Pacific Sardine Stock Assessment Review Panel Meeting Report

NOAA / Southwest Fisheries Science Center
La Jolla, California
February 24-27, 2020

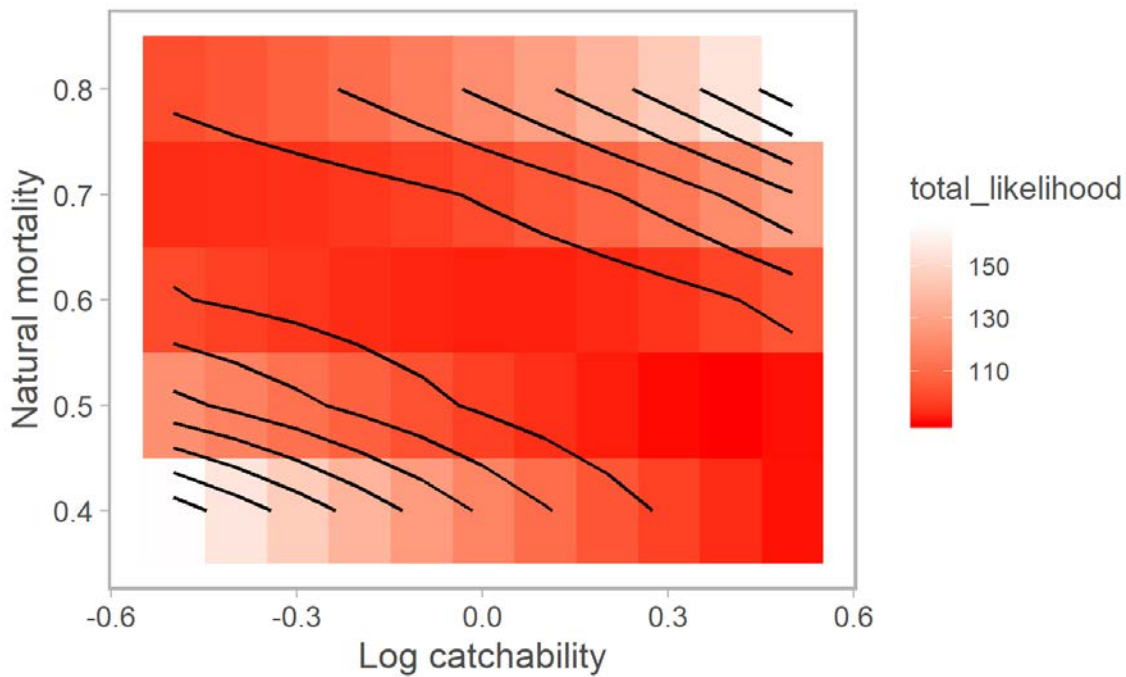
Request 23: Provide a joint likelihood profile across M and Q . Add standard profiles on M , steepness and Q . Also show how derived parameters change across the likelihood surface, e.g. 2020 season 1 biomass and stock depletion, where appropriate.

Rationale: M and Q are likely influencing the poor fits, a joint likelihood profile across M and Q would be helpful.

Response: Likelihood profiles for steepness show that recruitment drives the steepness profile. Likelihood profiles for M show that the data are informative and with little conflict between data sources. Likelihood profiles on M for only the age data sources showed that the PNW fleet wants a lower M , while the AT survey age data want a higher M . The likelihood profile for Q , using a single fixed Q , looks fine. The Q profile shows that the acoustic trawl survey wants a high Q value. The joint profile on M and Q , using a single fixed parameter for Q , showed the correlation between these two parameters. The Panel requests the STAT use a contour plot for this profile in the final document and a profile for Q that accounts for the change in Q in 2015.

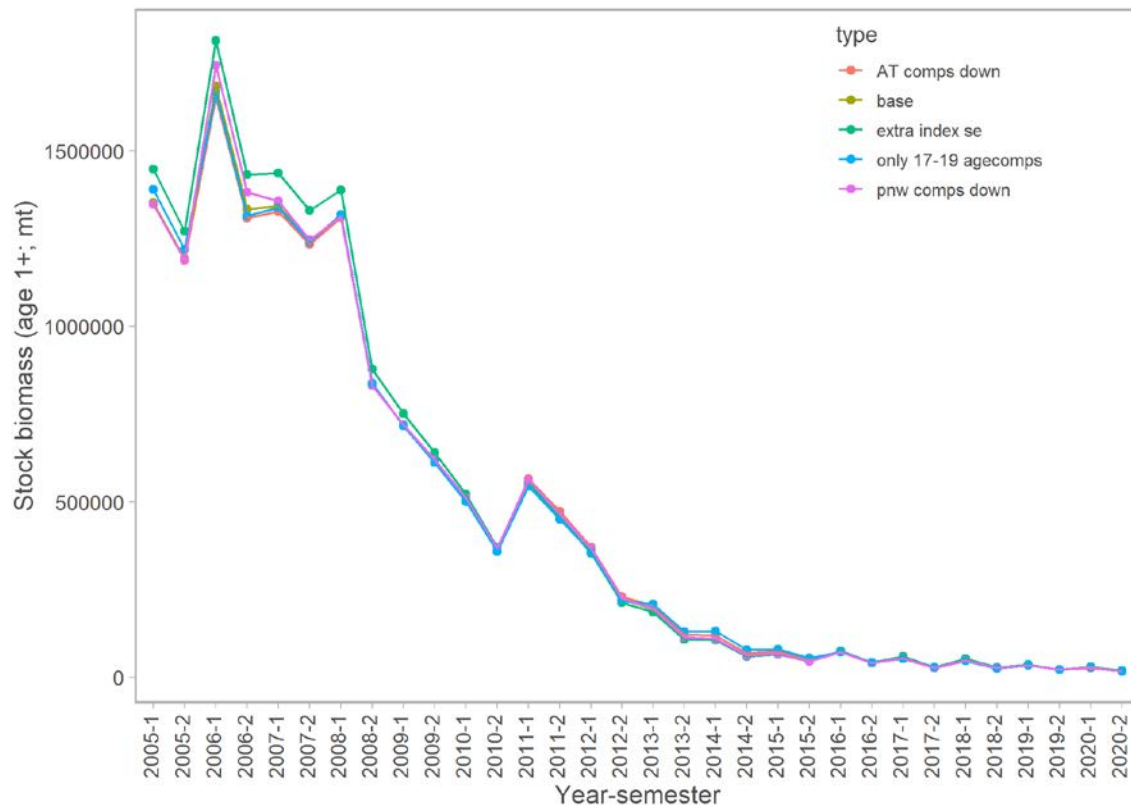
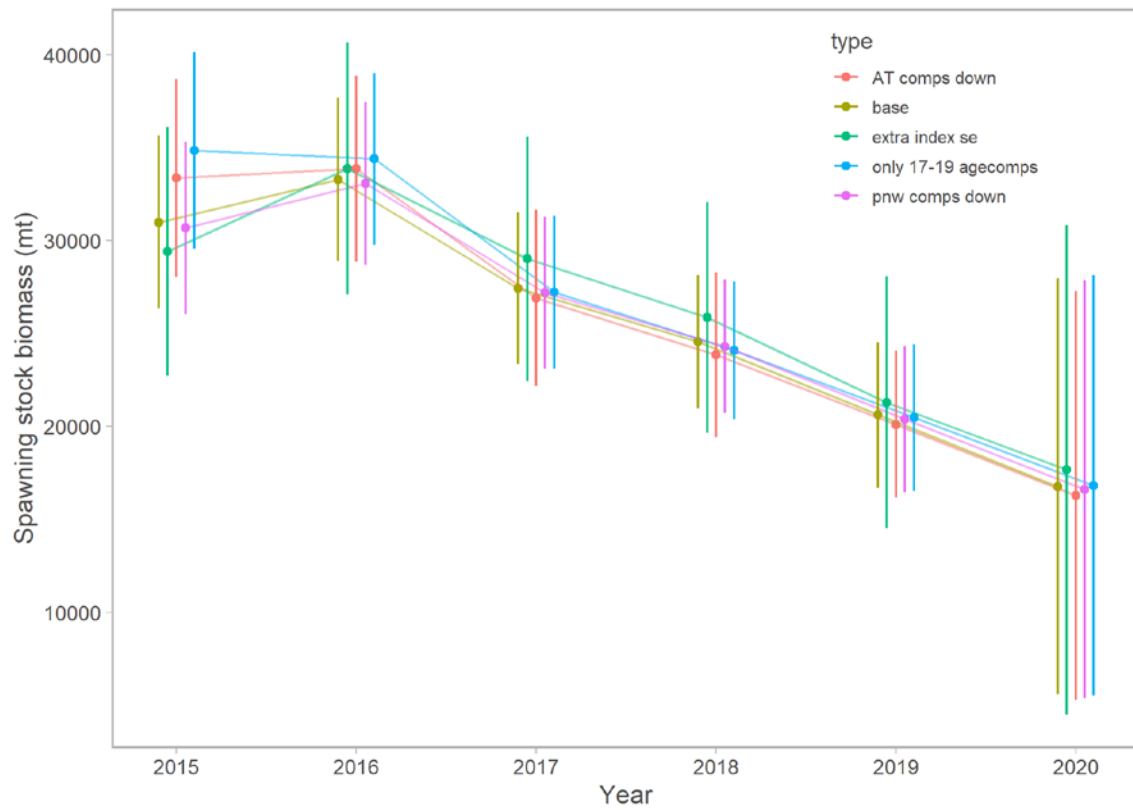
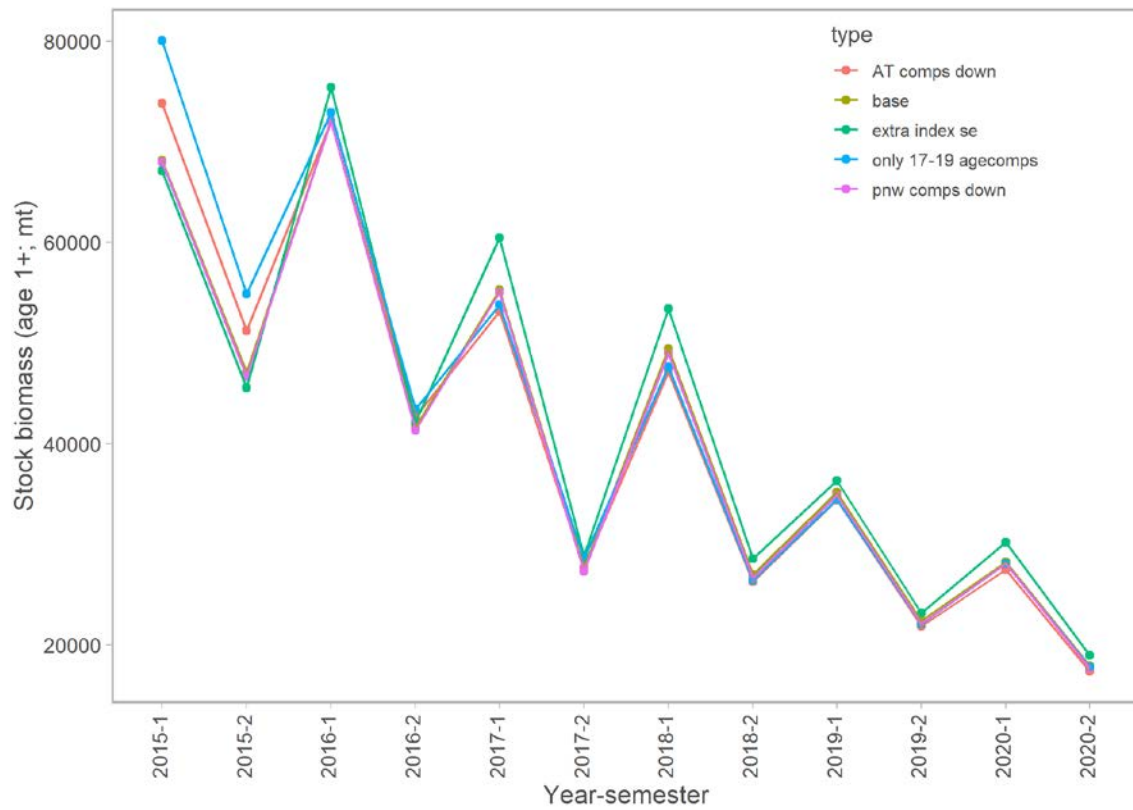
Request 24: Conduct additional sensitivity tests in which (a) the AT age data are down-weighted by 50%, (b) the PNW age data are down-weighted by 50%, (c) the AT age data are restricted to 2017 onwards, and (d) an additional variance parameter is estimated for the AT survey.

Rationale: The Panel wished to explore the sensitivity of the results of the weighting of the data.

Response: The time-trajectories of biomass (both long-term and recently) are robust to these changes. The estimate additional variance for the AT survey is 0.22.
